Kansas Department of Agriculture
 Division of Water Resources
CHANGE: P/U WORKSHEET

Water Right, File No. 39335
 Change in Place of Use, Application Map
 27-23S-2W // Harvey County

Re: Place of Use Change Applications, File Nos. 4139, 37586, 39335 – Merlin Unruh

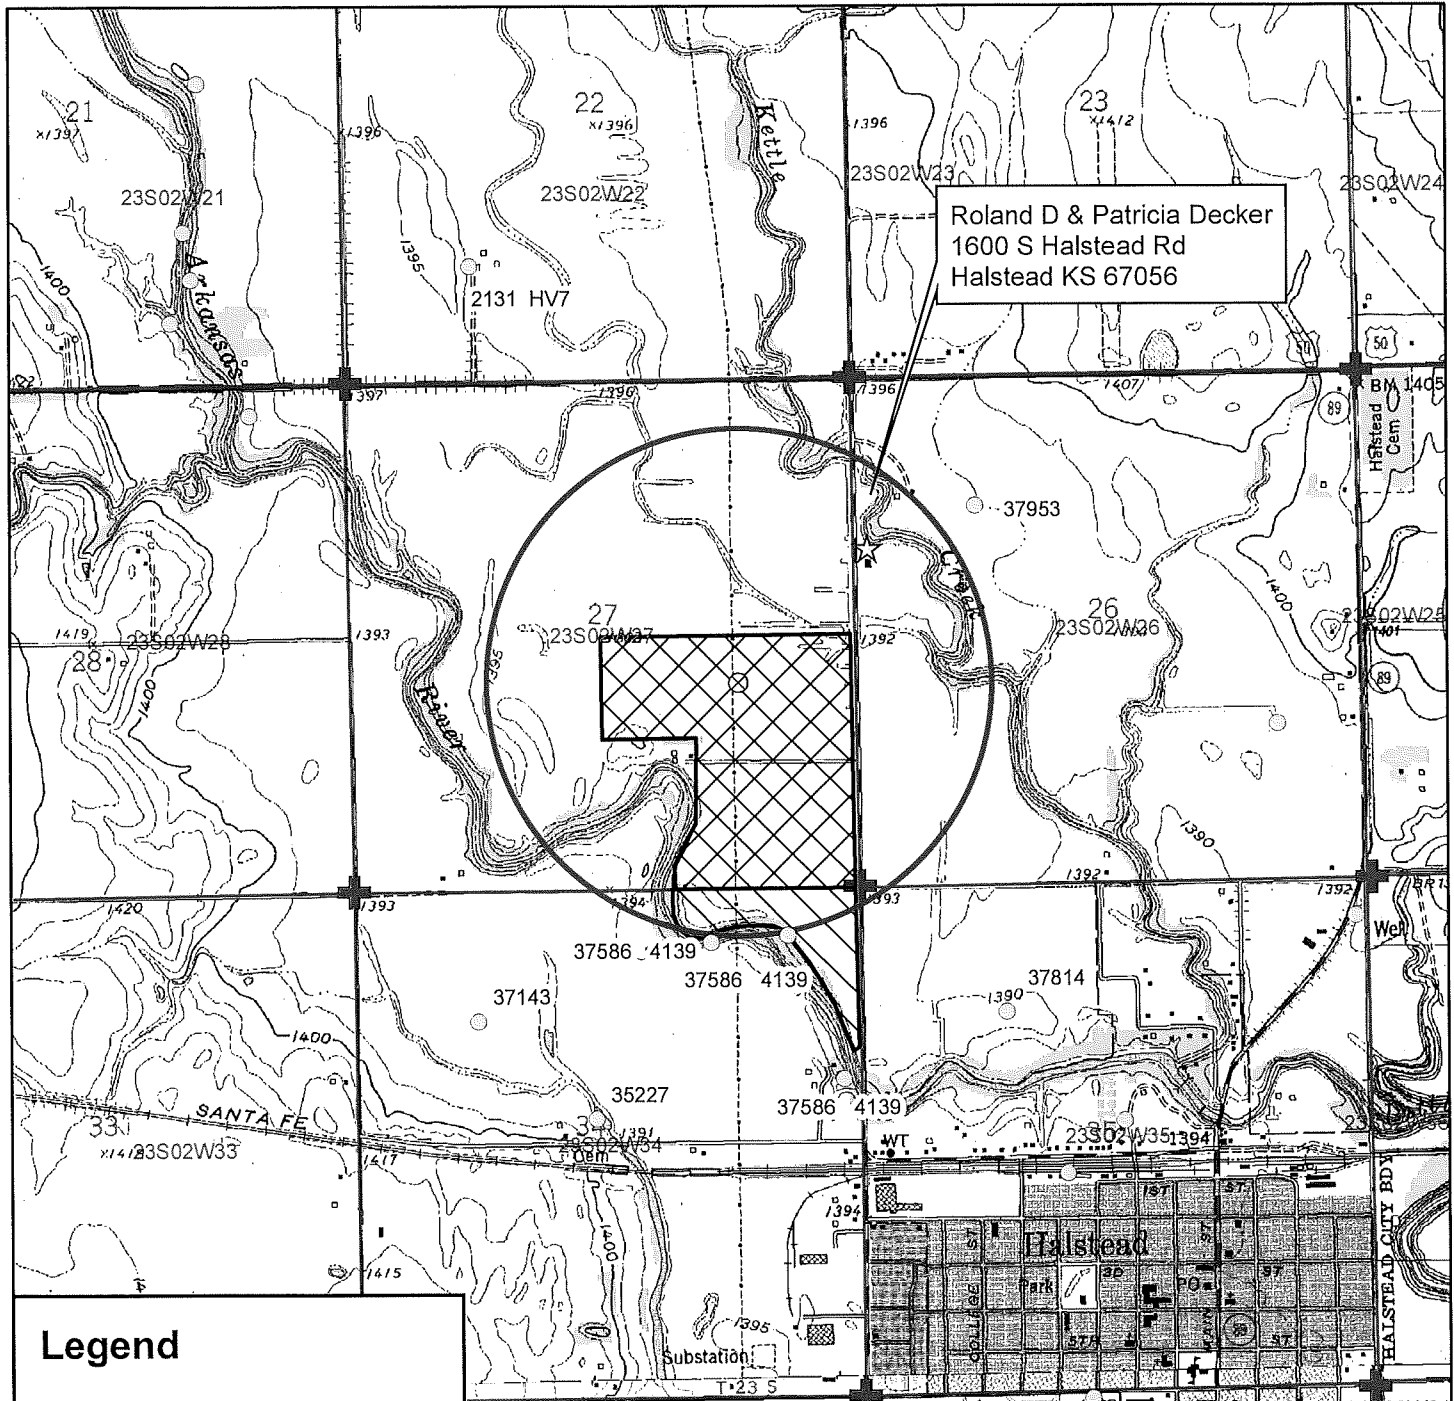
Review completed for an application to change the place of use submitted by Merlin Unruh.
 Application proposes to increase the place of use from 124 acres to 155 acres and overlap the place of use and form identical place of use overlap with change applications filed on surface water rights Nos. 4139 & 37586
 The proposed place of use is 155 acres and no new acres are proposed between the files - changes filed only for the purpose of creating an identical place of use overlap between the files. Therefore, base acre review is not necessary
 Water right no 39335 - Authorized for 165 AF groundwater
 Water right no 4139 - Authorized for 46.5 AF surface water
 Water right no. 37586 - Authorized for 35 AF surface water (due to limitation with No. 4139, net quantity = 0 AF)

Item 13: 165 AF / 155 acres = 1.06 AF/A. Total combined is 211.5 AF / 155 acres = 1.36 AF/A
 Recommend Approval, complies with K.A.R. 5-22-1 through 5-22-17

The District's review found that the change applications comply with the Revised Aquifer Management program approved by the Chief Engineer and with the District's Rules and Regulations K.A.R. 5-22-1 through 5-22-17. Based upon the review, the applications are recommended for approval by the Equus Beds Groundwater Management District No. 2.
